Interactive comment on "Optimal Site Selection for Sittinga Solar Park using Multi-Criteria Decision Analysis and Geographical Information Systems (GIS)" *by* Andreas Georgiou and Dimitrios Skarlatos

Andreas Georgiou and Dimitrios Skarlatos

We would like to extend our sincerest gratitude to the reviewer for the very useful comments and suggestions. The review was very motivating and inspiring. We will respond to the comments and questions below in the order that they were presented.

Fig. 1. (a) Constraint map; (b) Evaluation map; (c) Final SI map of study area as extracted from the multiplication of the Constraint map with the Evaluation map; (d) Distribution of SI pixels over final map

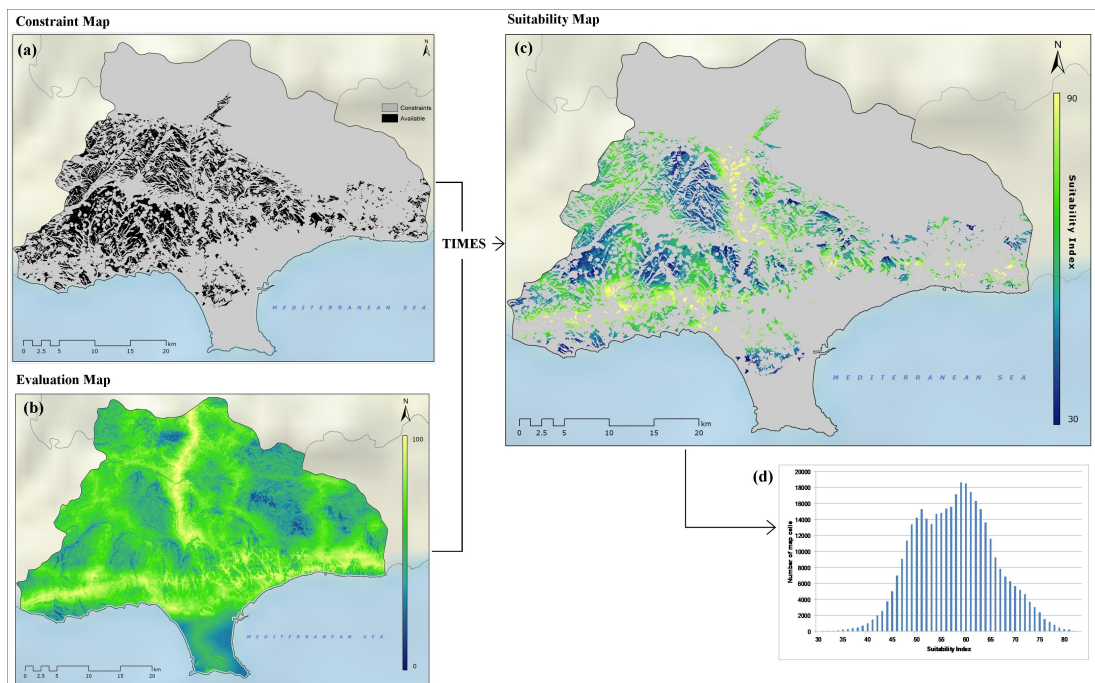
[Comment #2]: Please explain the Figures 2-7 in the text and especially the Figure 7. Results should be explained in detail.

[RESPONSE]: Figures 2 to 7 and the results are briefly explained through the text. We have made some changes in the order of the Figures to address the change in the structure of the paper. In addition, some changes were made in Figures 5 & 6 in order to present better the results and an additional Figure 7 created to present the classified results of the sensitivity analysis (Figure 4 removed as mention in Comment 5 of the MINOR COMMENTS section).
